A57 Link Roads

TR010034

**9.60 Applicant's responses to Examining
Authority's Second Written Questions**

March 2022

16. Compulsory Acquisition, Temporary Possession, Statutory Undertakers and funding	99
Appendix A. Plans showing changes in bus journey times by route sections (links)	101

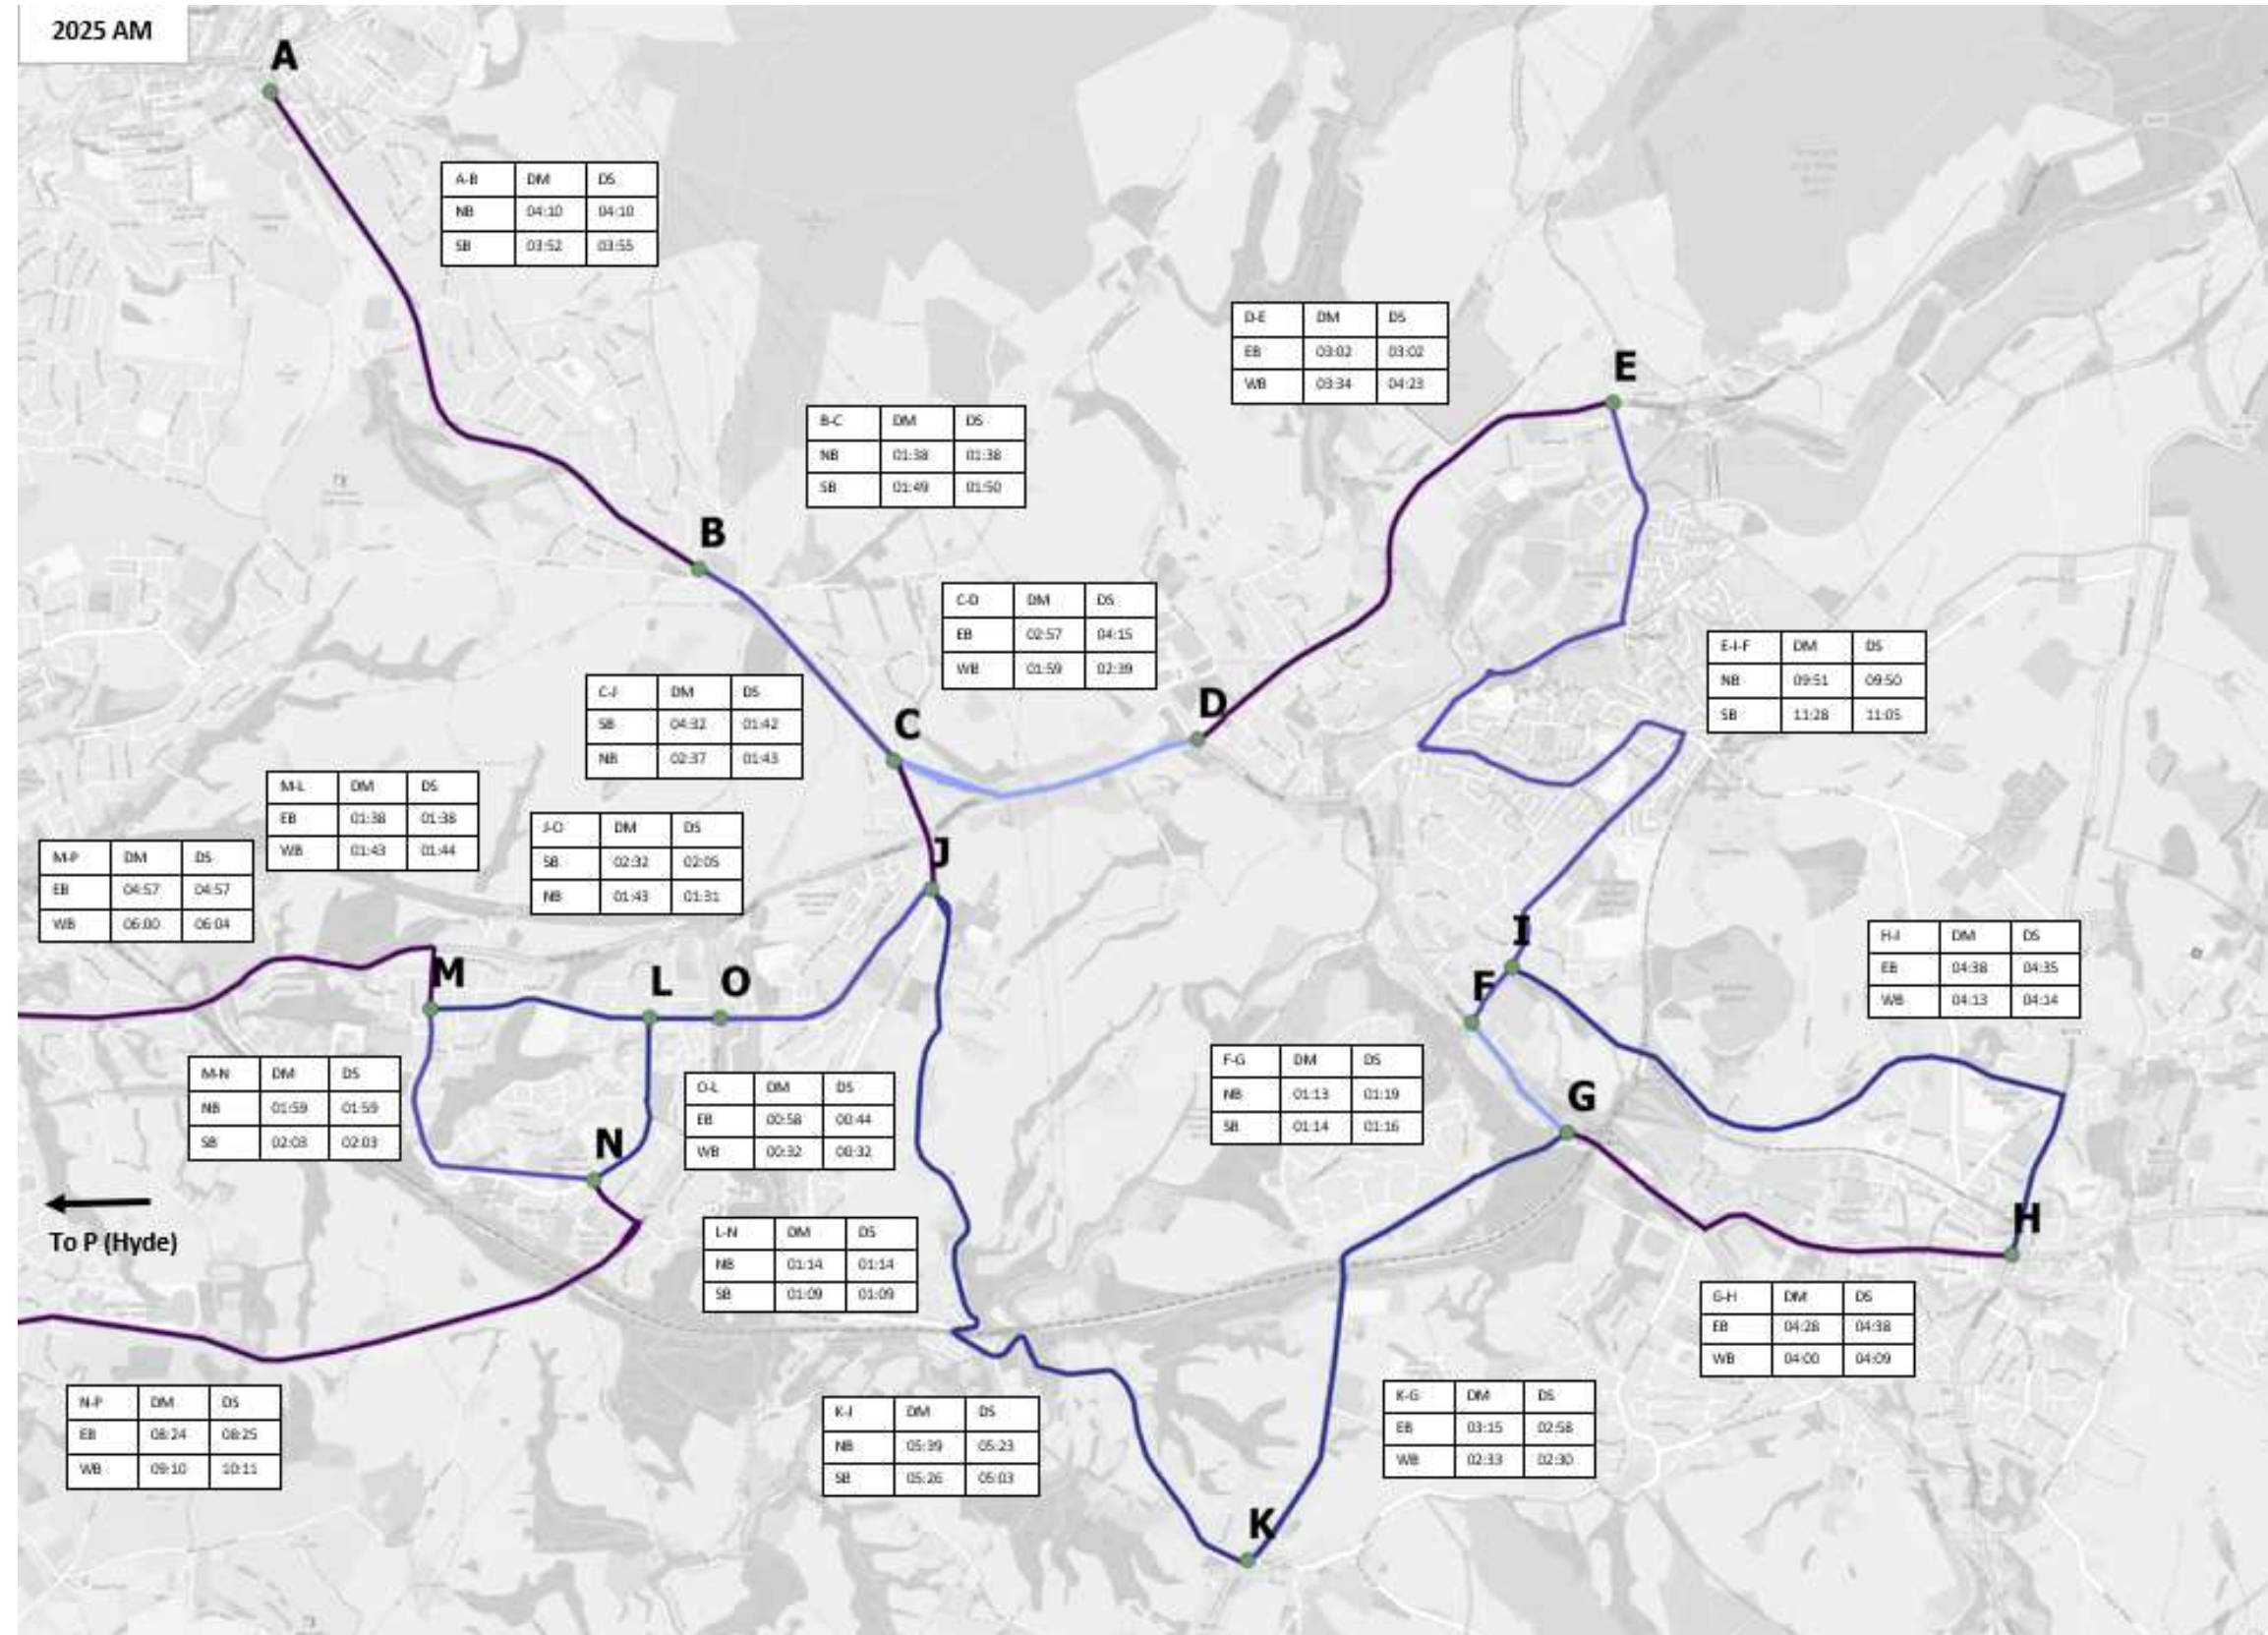
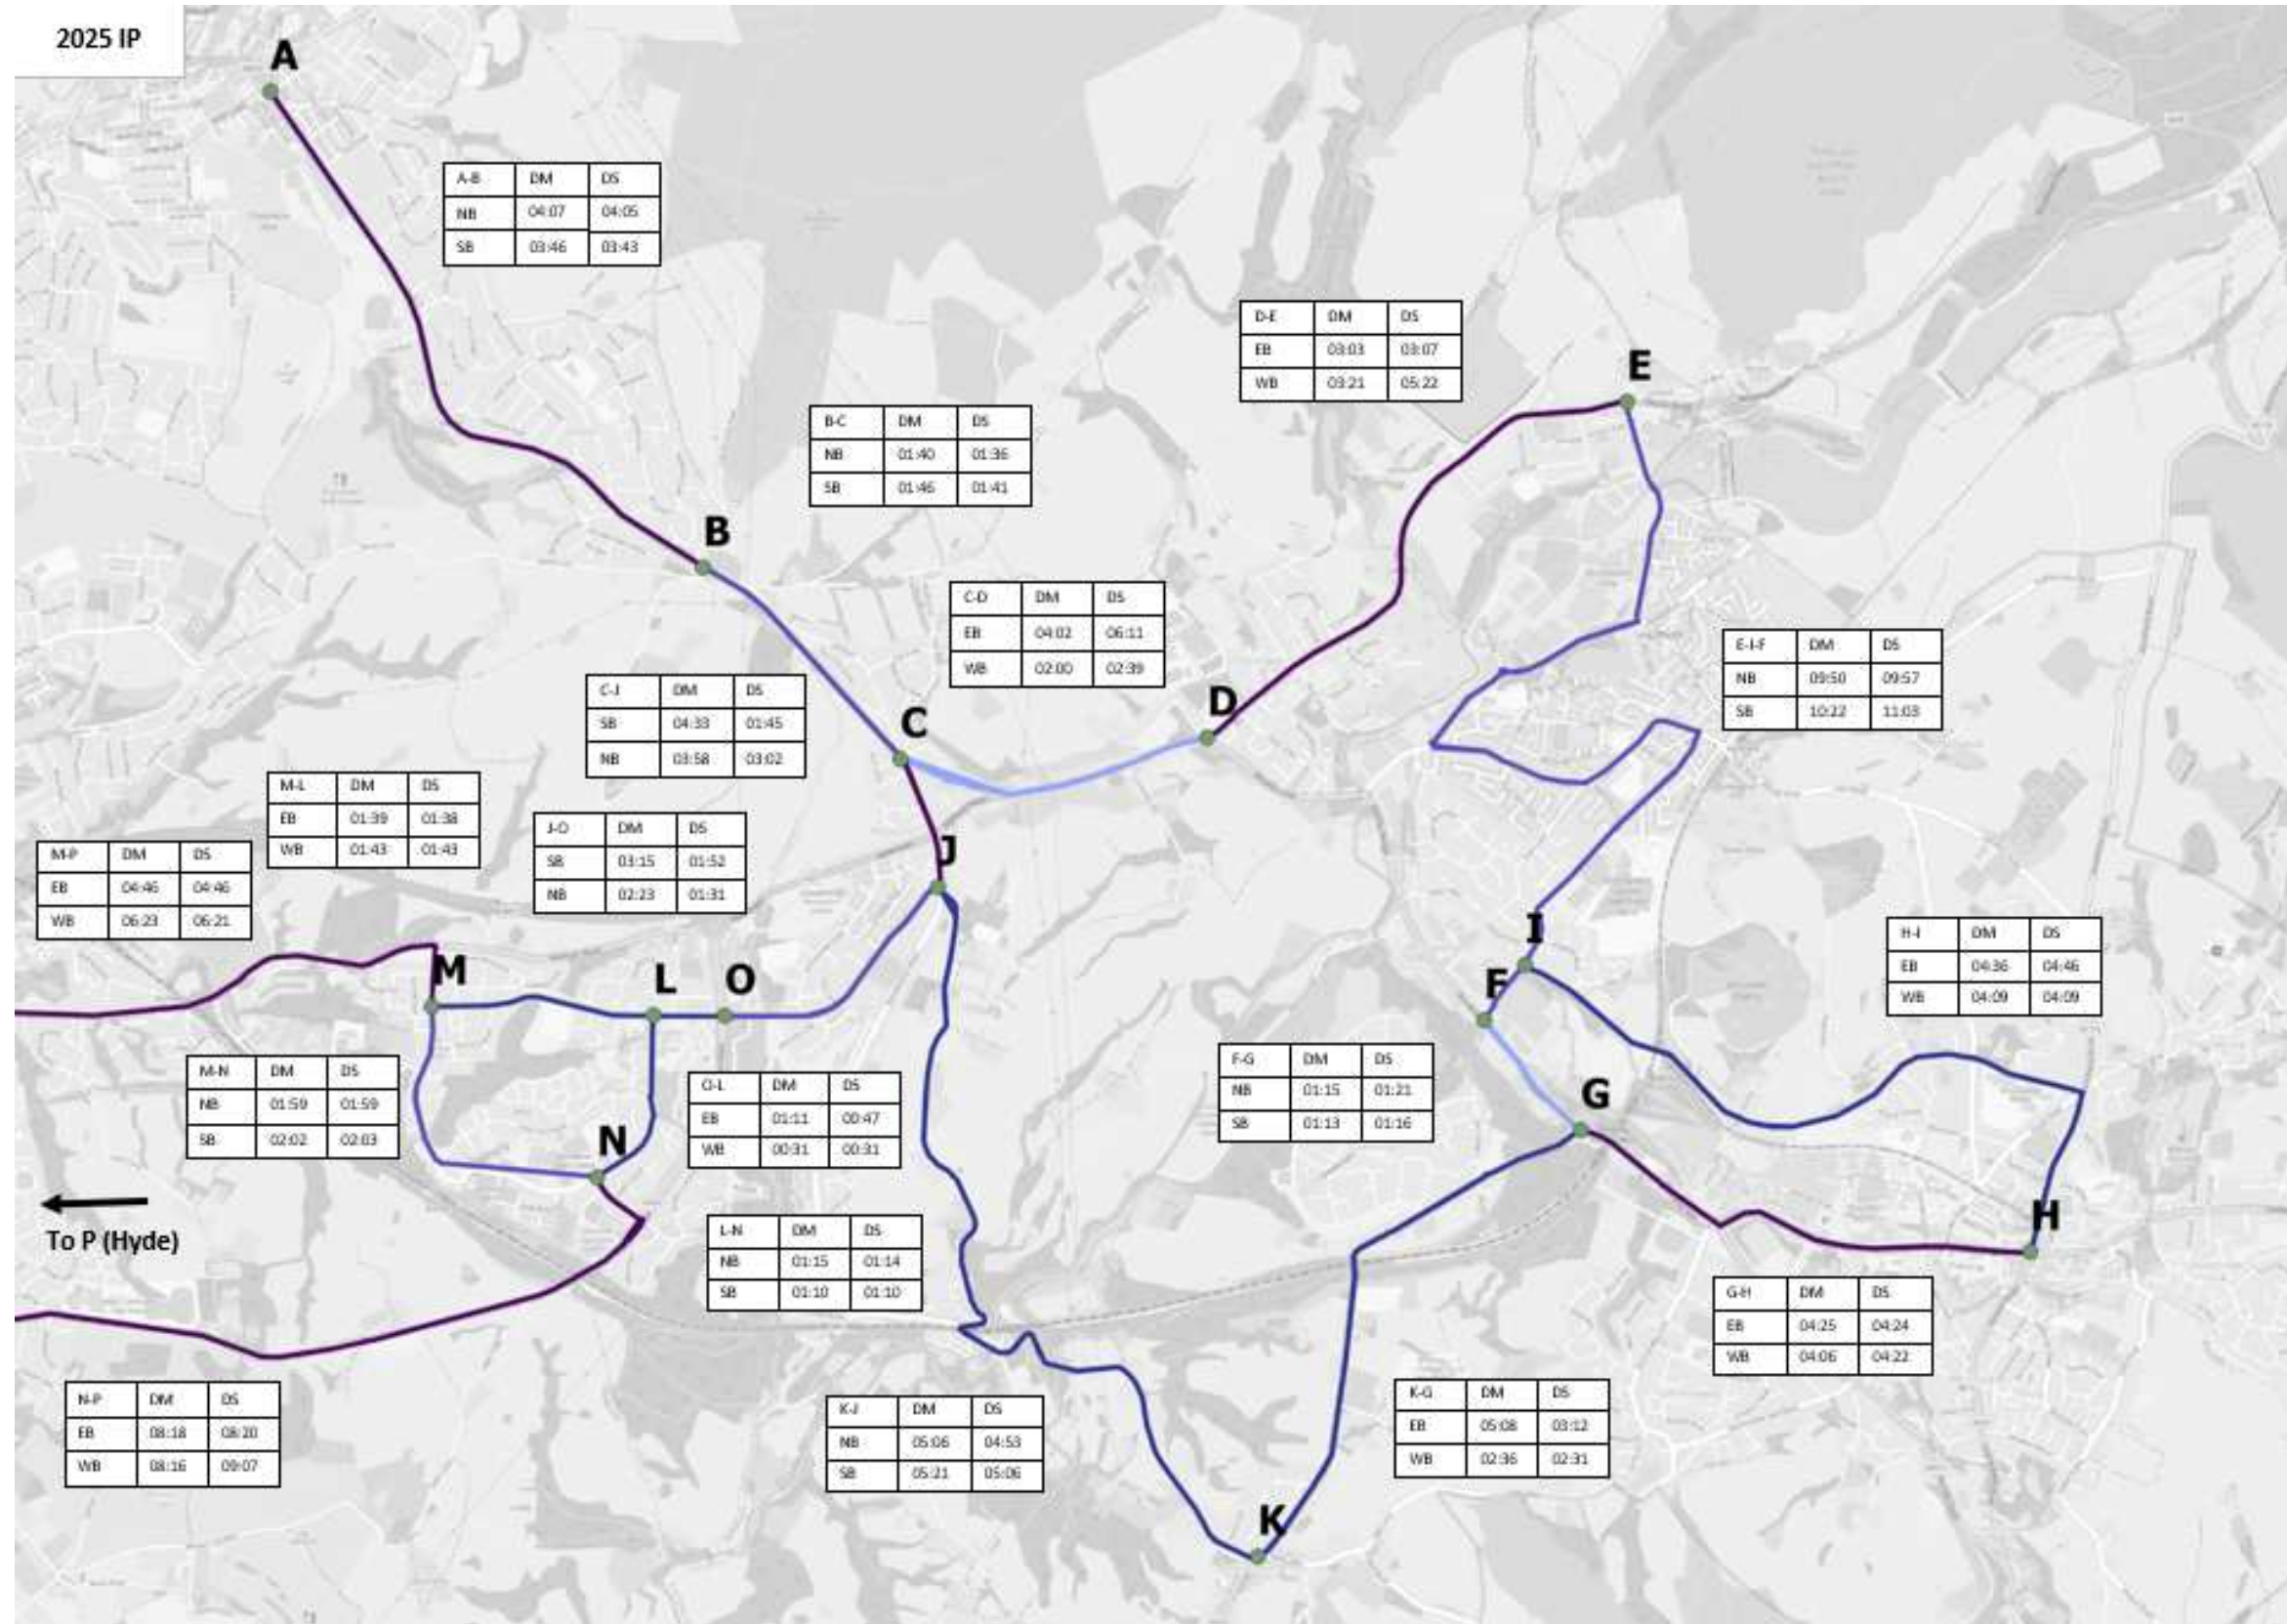
No	Question to	Reference	Question	National Highways' response																																																																																																																																																
3. Transport networks and traffic, alternatives, access, severance, walkers, cyclists, and horse riders																																																																																																																																																				
Public transport																																																																																																																																																				
3.17	Applicant	Bus journey times	<p>It is likely that buses will remain on routes using the existing road network, rather than using the links provided by the proposal. The information provided on bus travel times within the application is limited.</p> <p>Please provide, preferably in diagrammatic form, a breakdown of link journey times for local bus routes, showing, for each link, predicted journey times for the Do-Minimum and Do-Something scenarios, in opening and design years for journeys within the Local Study Area.</p>	<p>The tables below present the anticipated whole route changes in bus journey times due to the Scheme for the AM, Inter and PM peak periods for both 2025 and 2040. The changes in journey times presented are only those for when the bus is travelling on roads included in the traffic model. They excludes bus dwell times at bus stops and journey times where the buses are travelling along streets in residential areas not included in the traffic model, which are not anticipated to change due to the Scheme.</p> <p>Plans showing these changes in bus journey times by route sections (links) are provided in Appendix A.</p>
